CITY OF ALBUQUERQUE

**Re: Los Candelarias Townhomes – Entire Site, 3624 & 3628 10th St NW,
Request for Permanent C.O. –Accepted
Engineer's Stamp dated: 09-29-11, (G14/D073)
Certification dated: 09-20-12**

**Re: Los Candelarias Town homes, Grading and Drainage Plan
Engineer's Stamp date 5-11-12 (G14/D073)**

**Re: Los Candelarias Town homes, Grading and Drainage Plan
Engineer's Stamp date 9-29-11 (G14/D073)**

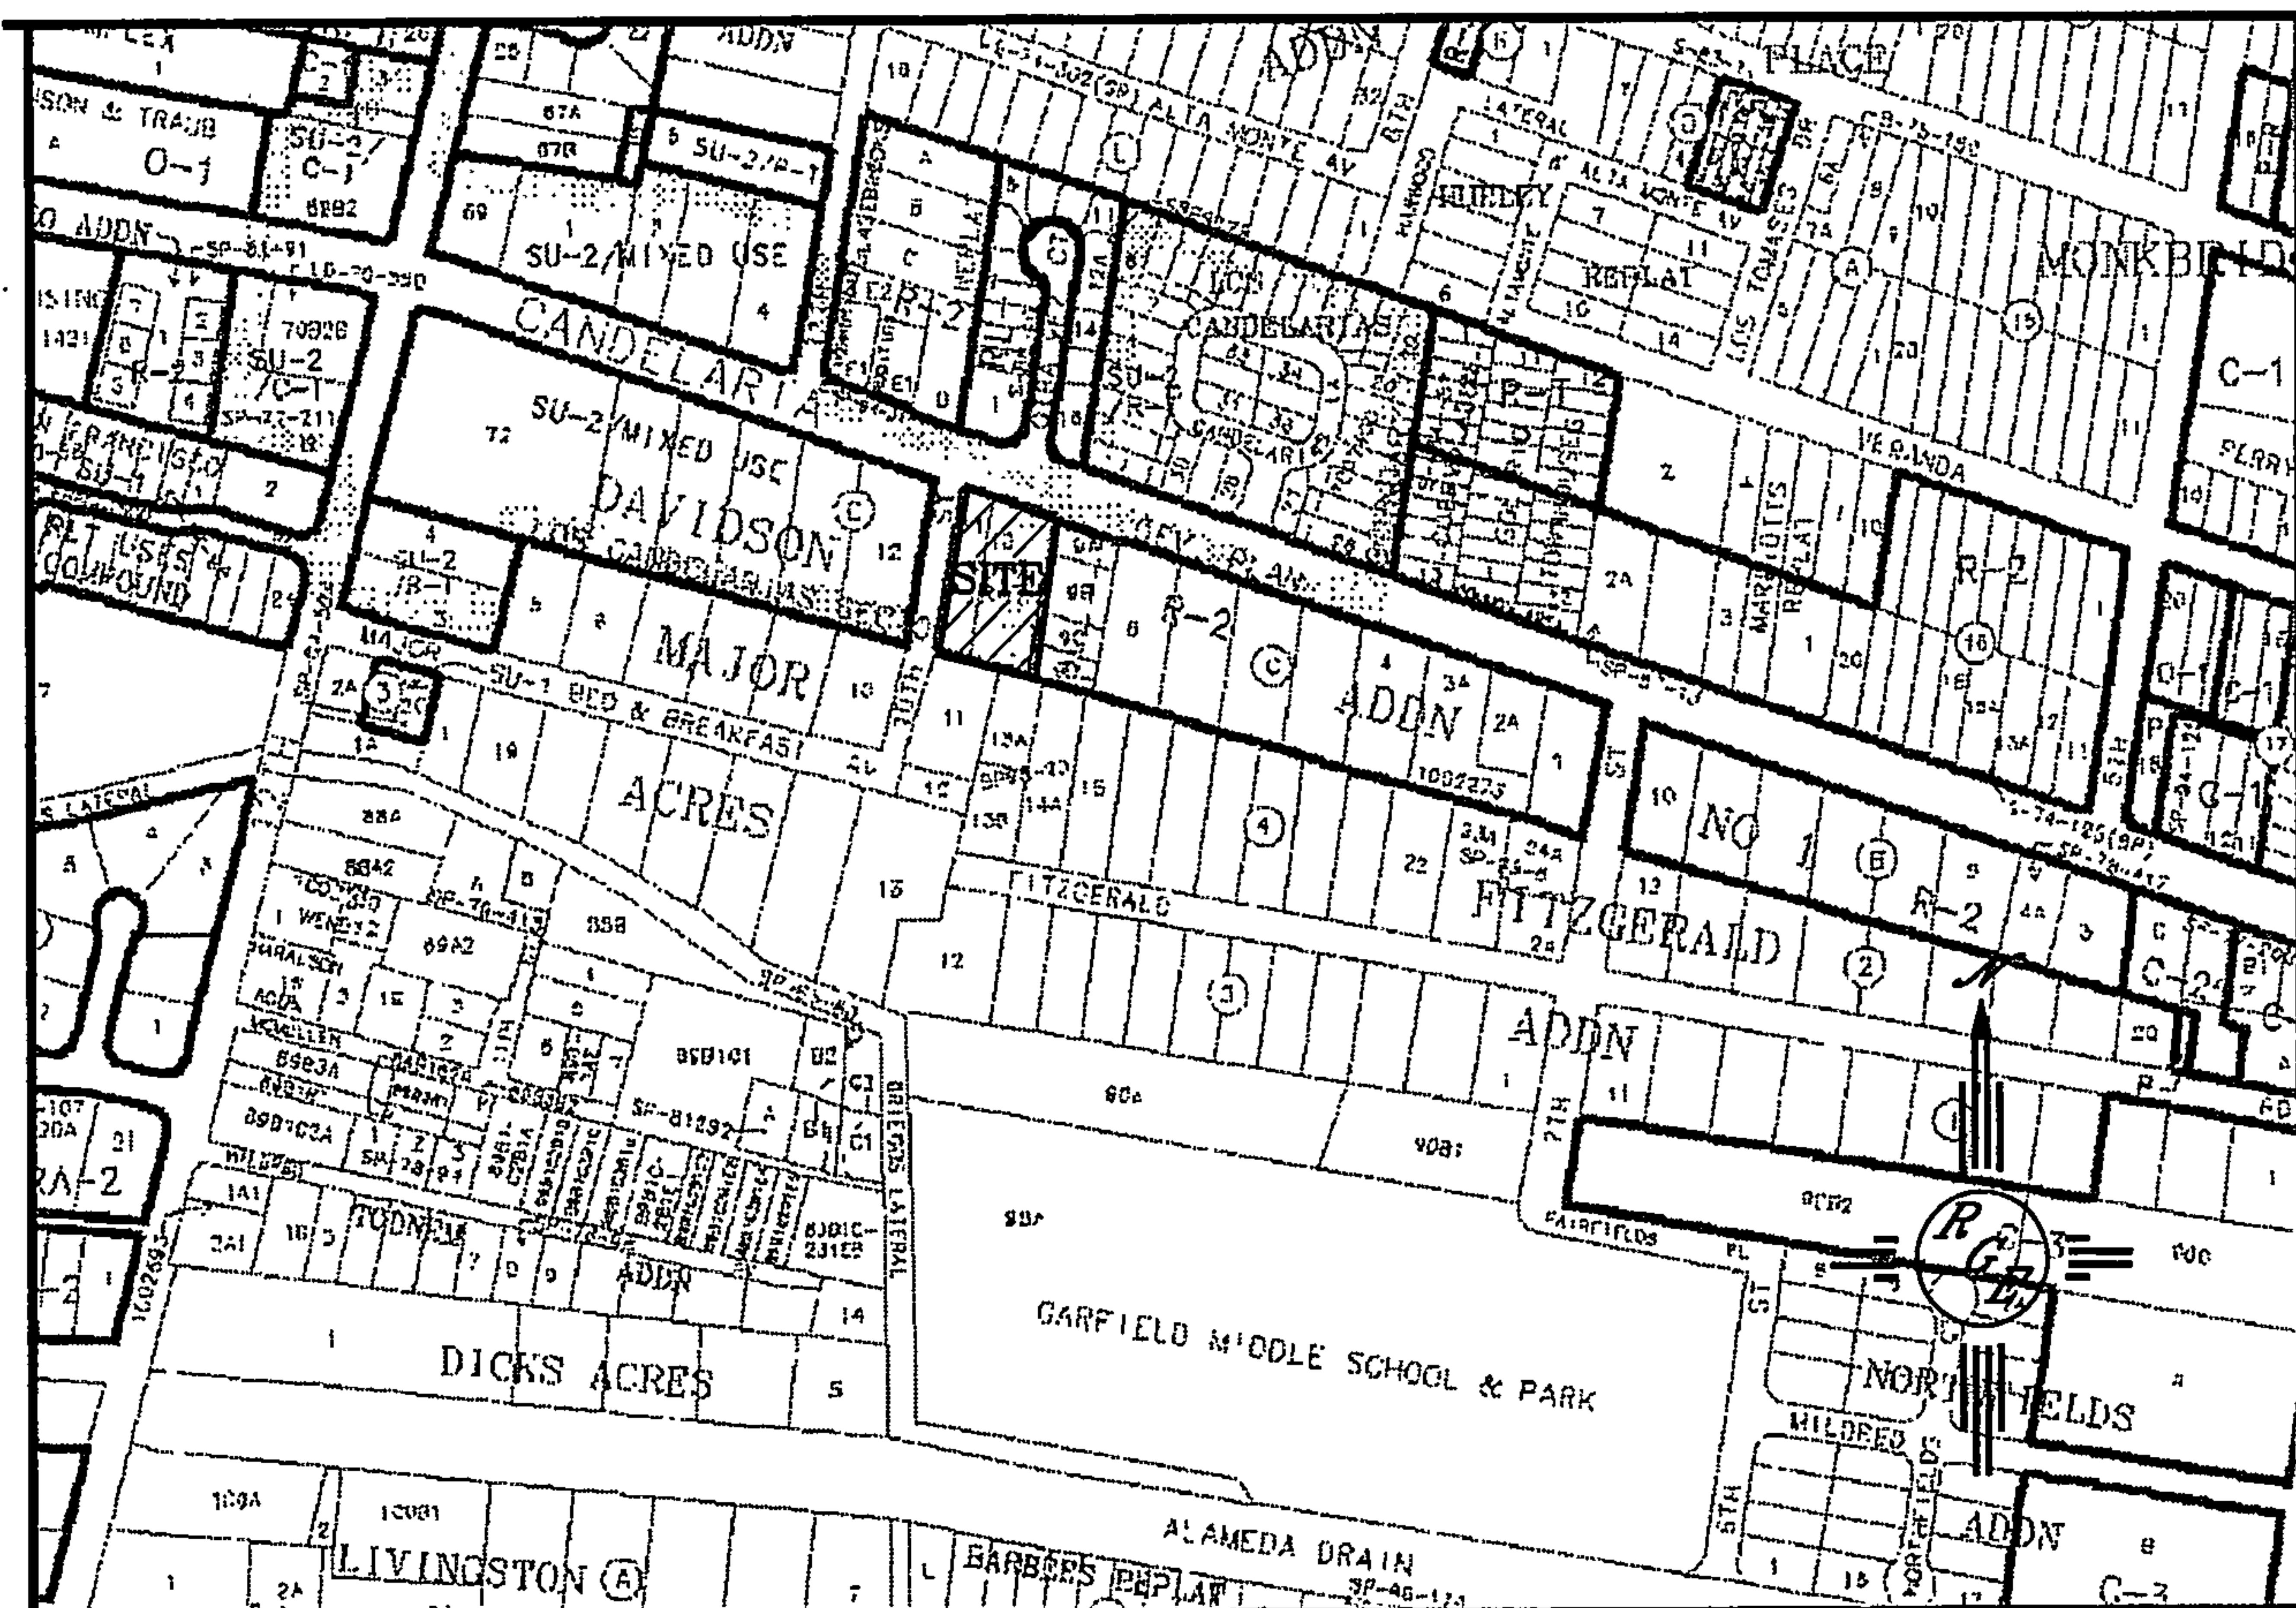
- The build note for the pond behind Bldg 3 specifies a 1.5 ft deep pond, whereas the grades show only 1 ft. In the interest of this pond not being filled in the future, Hydrology would prefer the pond to only 1 ft deep. The difference in runoff can be made up by draining a portion of the parking lot into the landscape areas in the parking area. These landscape areas could be 1 foot deep, similar to the other water harvesting areas on the plan.
- Is the south wall in a MRGCD easement?
- Please use a 1"=20' scale. There is a lot of white space on the plan.
- Provide flow line spot elevations at the proposed drive pad on 10th Street.
- The sidewalk along Candelaria Rd appears to be new. The plan shows proposed grades at back of sidewalk. Seems existing grades at the back of sidewalk should be provided.
